PROJECT: TTU TRACK AND FIELD
SBC# 364/011-05-2025
BAA Project Number 25007
Cookeville, Putnam County, Tennessee

SUBJECT: Addendum No 1

- 01 WALL SECTION
@ TYP. BRICK WALL

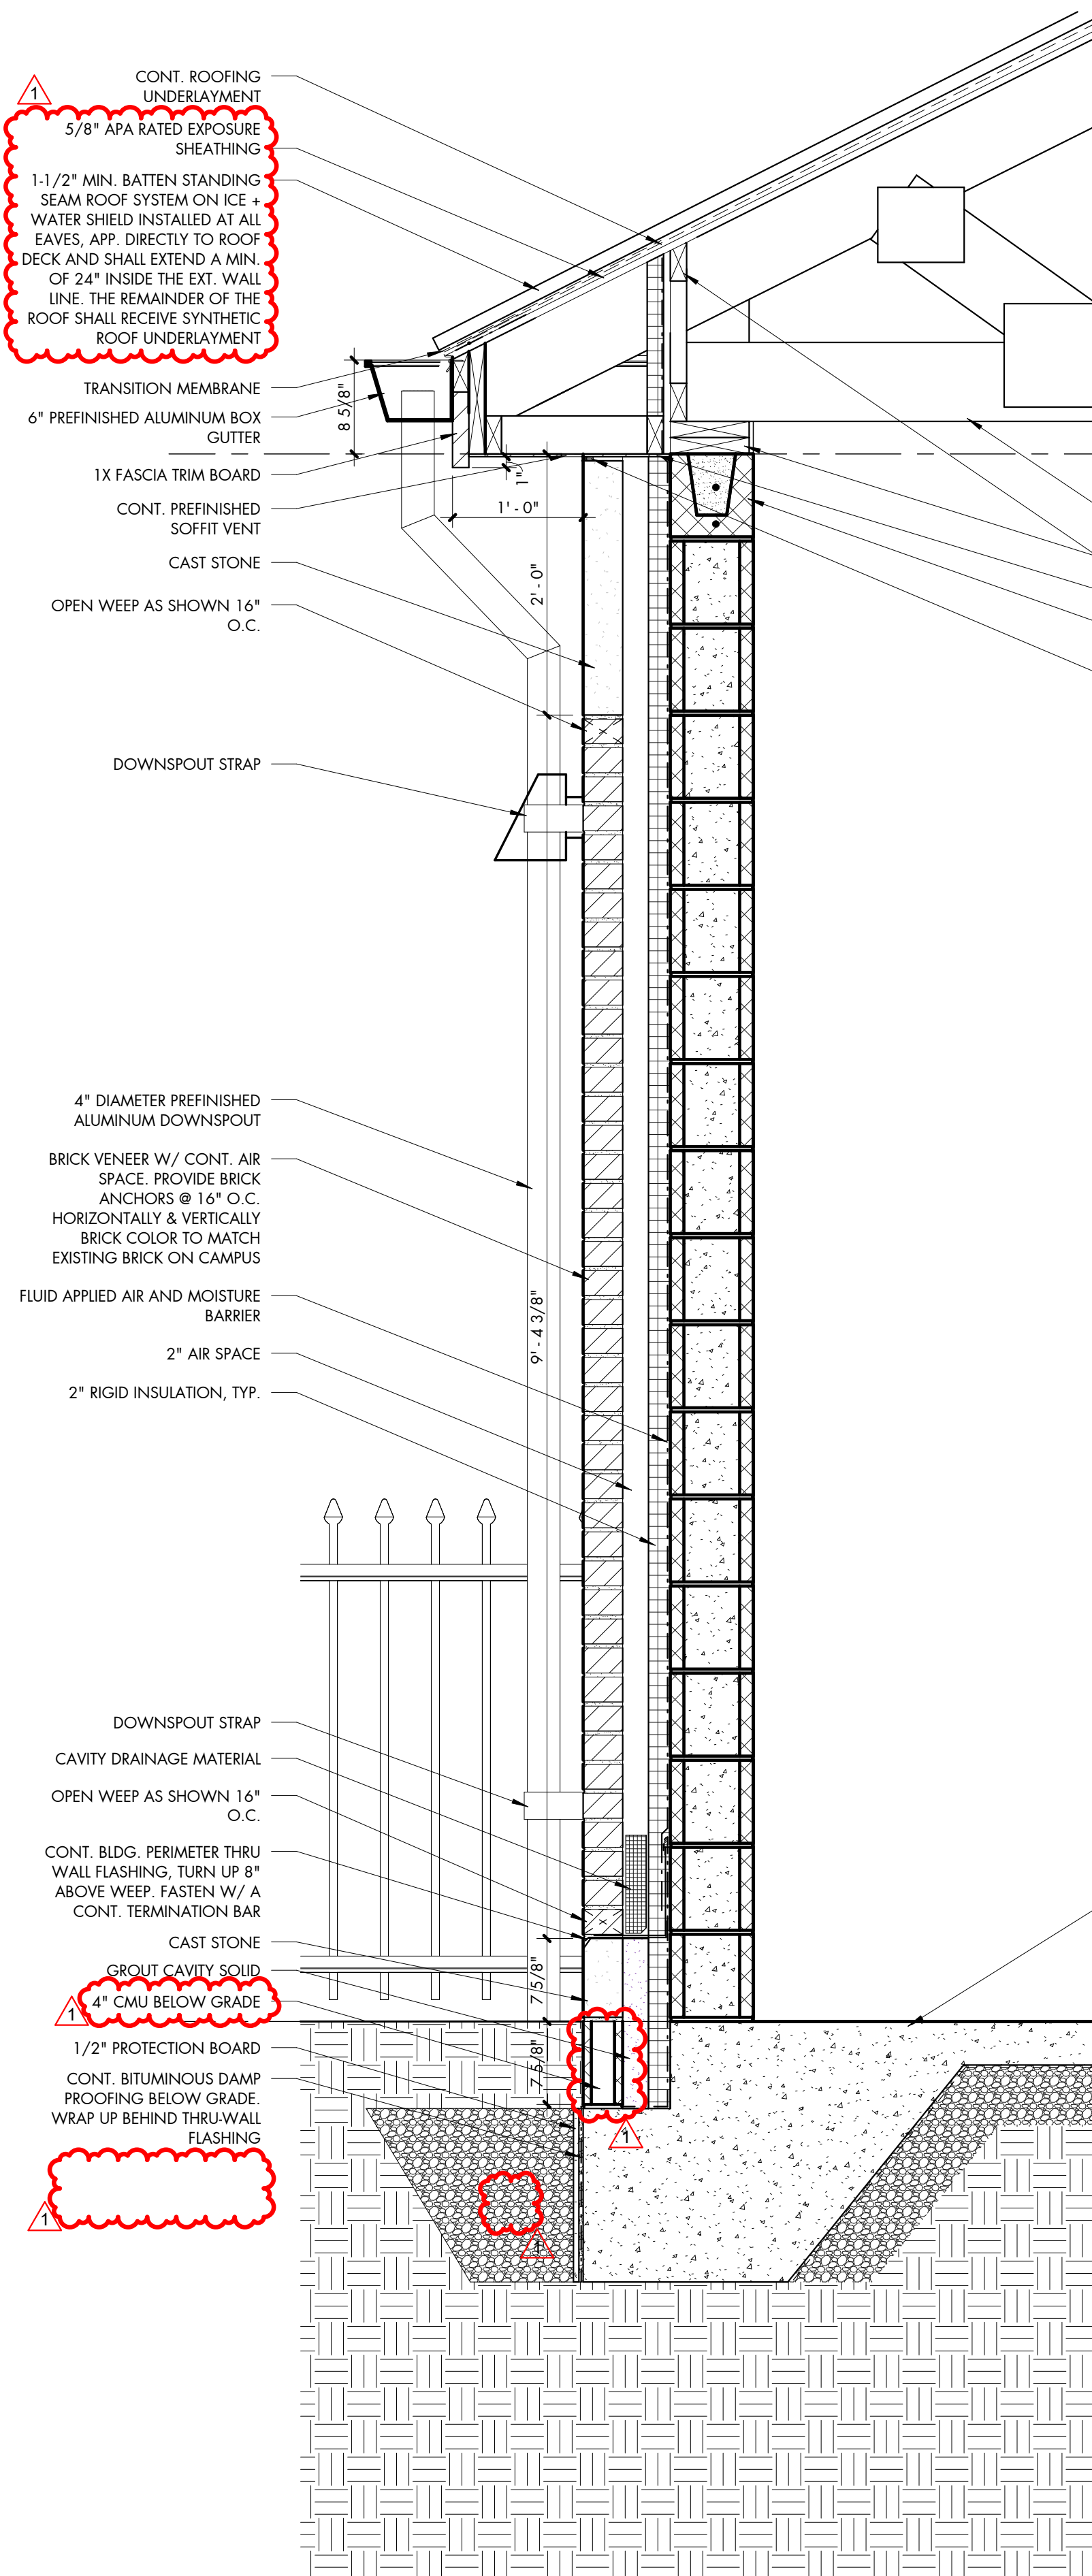
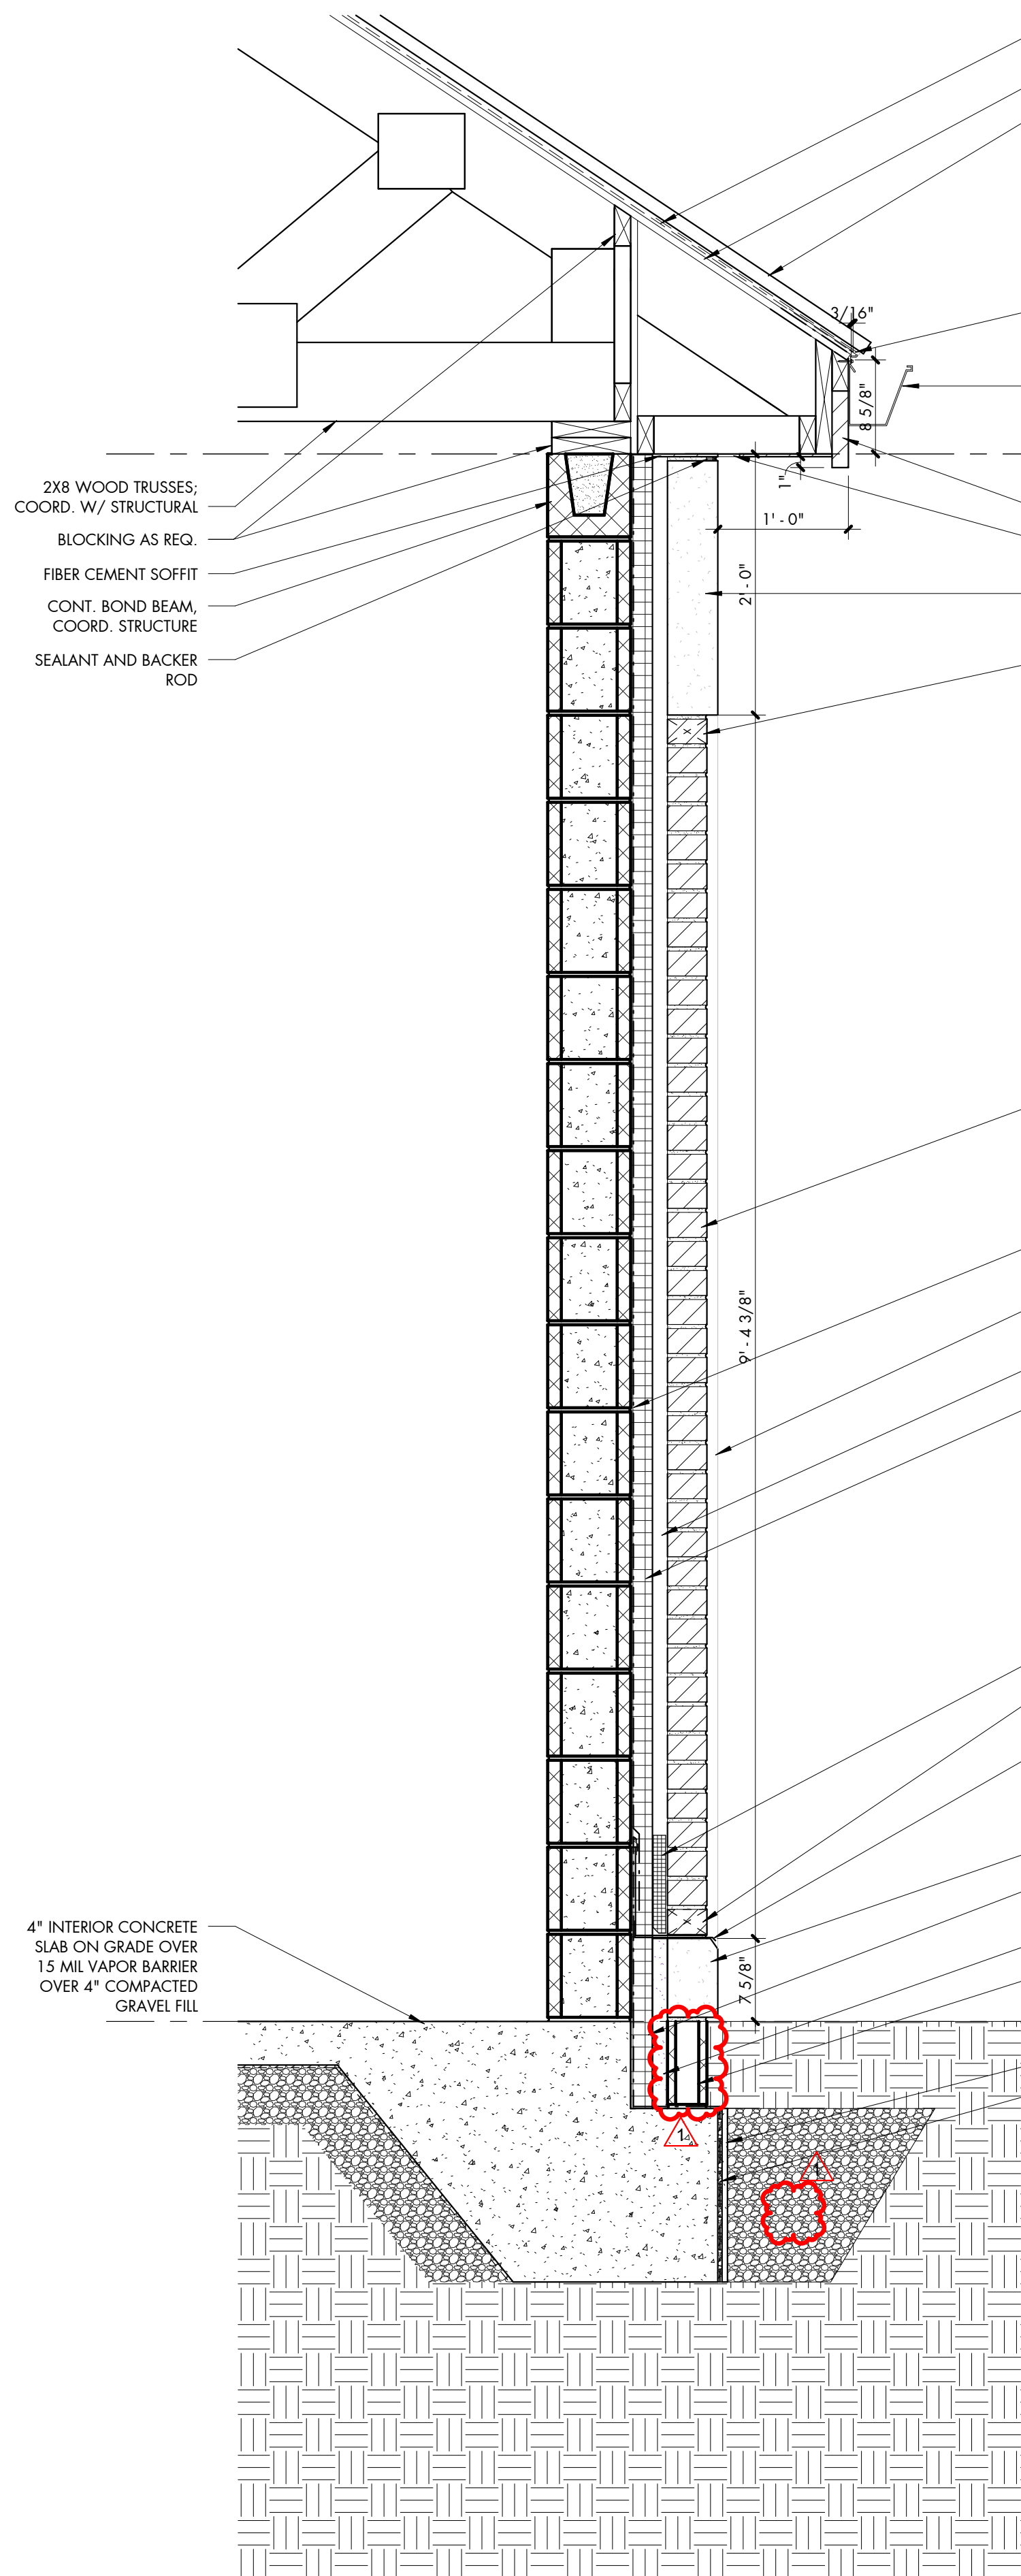
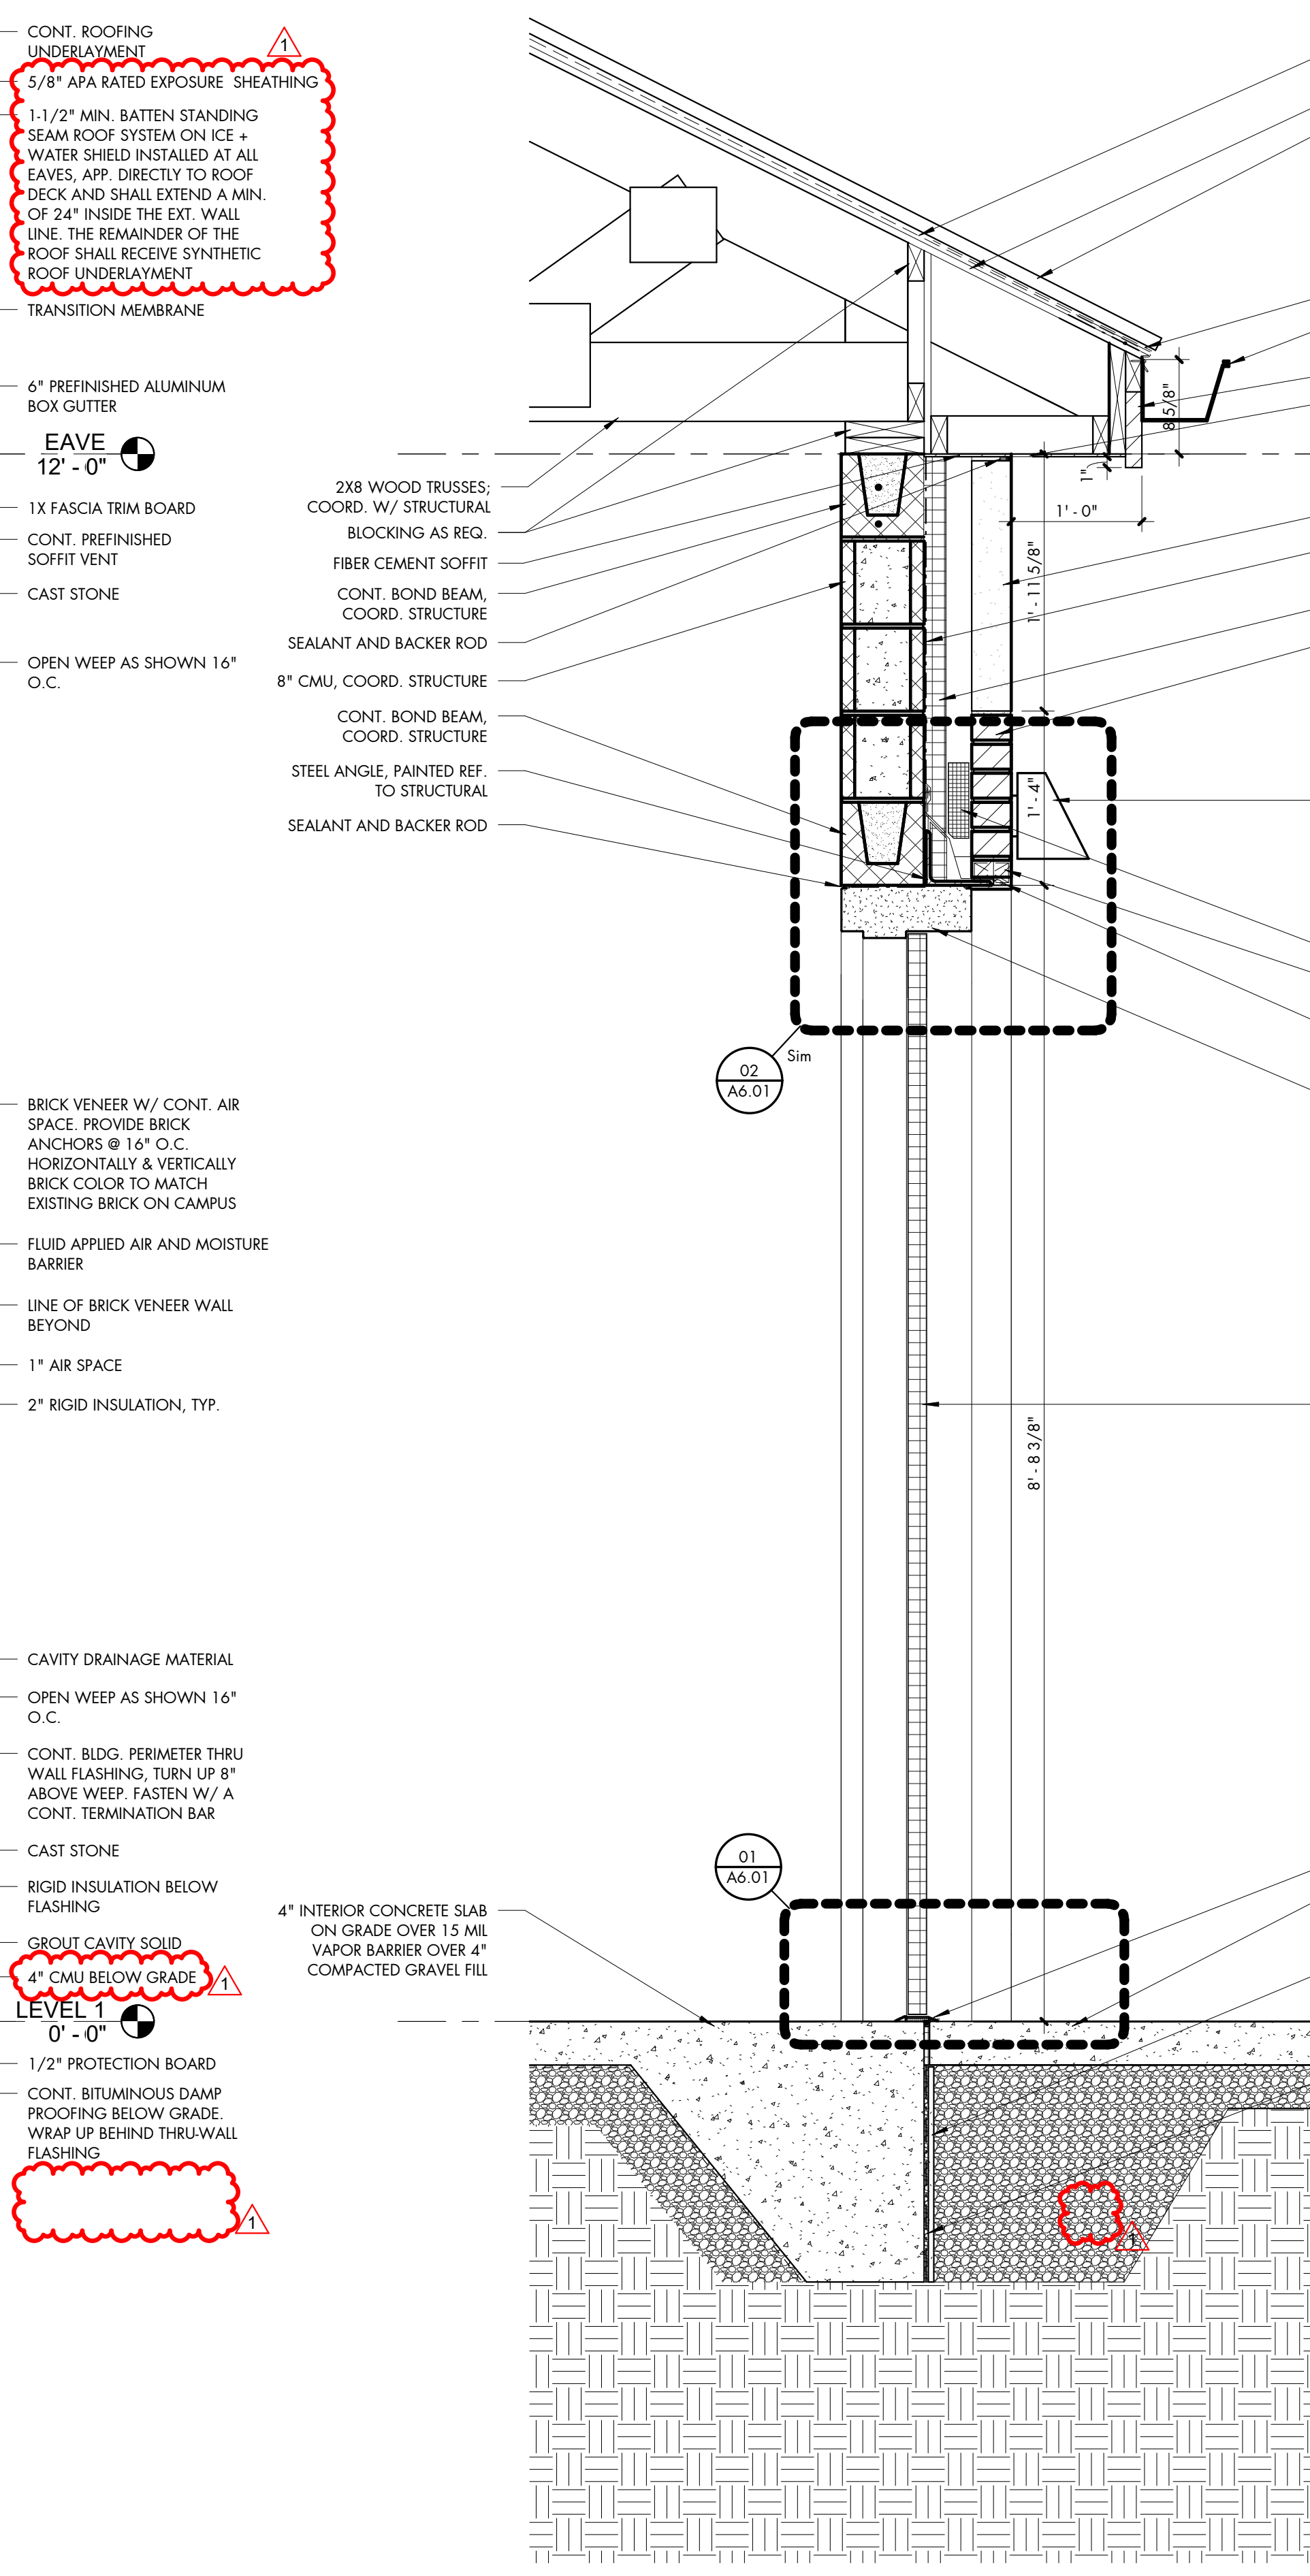
102. Question: A4.10 appears to show precast masonry extending below grade. Is this intended?

Answer: Provide 4-inch solid CMU at the foundation. Refer to the revised wall sections on Sheet A4.10.
